Access Compliance Report

Public Rights-of-Way

(Curb Ramps)

Intersection ID: 10041624	Main Street: WHITEHALL_EXECUTIVE_CENTER_DR	Cross Street: N/A	Location: NE
ADA ID: 68E915729041	Ramp Type: Perp	Initial Pass/Fail: Fail	Overall Compliance: No
Severity Score: 8.75			
Codes/Mitigation Info/Possible Solution		Field Measurements/Component Compliance

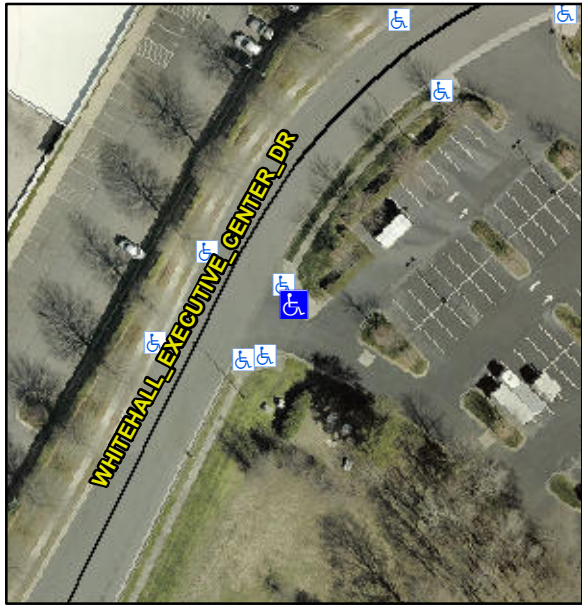
Not Found, R304.5.1

Compliance	Description	Data	Compliance	Description	Data
N/A	Ramp Length (in)	94.0	Yes	Ramp Slope (%)	7.7
No	Ramp Width (in)	41.0	Yes	Ramp XSlope (%)	0.0
N/A	Flare Type LT	N/A	N/A	Flare Type RT	N/A
N/A	Flare Slope LT (%)	N/A	N/A	Flare Slope RT (%)	N/A
N/A	Flare Traversable LT?	N/A	N/A	Flare Traversable RT?	N/A
N/A	Landing Length (in)	N/A	N/A	DWS Provided?	N/A
N/A	Landing Width (in)	N/A	N/A	DWS Contrast?	N/A
N/A	Landing Slope (%)	N/A	N/A	DWS Length (in)	N/A
N/A	Landing X Slope (%)	N/A	N/A	DWS Full Width?	N/A
N/A	Landing Curb? (Y/N)	N/A	N/A	DWS Offset (in)	N/A
N/A	Shared Landing?	N/A			
N/A	Gutter Ponding?	N/A	N/A	Gutter Slope (%)	N/A
N/A	Gutter Lip Ht (in)	N/A	N/A	Gutter X Slope (%)	N/A
N/A	Painted X Walk1?	No	N/A	Painted X Walk2?	N/A
	X Walk 1 Direction	To S		X Walk 2 Direction	N/A
N/A	X Walk 1 Width (in)	N/A	N/A	X Walk 2 Width (in)	N/A
	X Walk 1 Slope (%)	3.3		X Walk 2 Slope (%)	N/A
	X Walk 1 X Slope (%)	0.5		X Walk 2 X Slope (%)	N/A

Remove & Replace Entire Ramp.
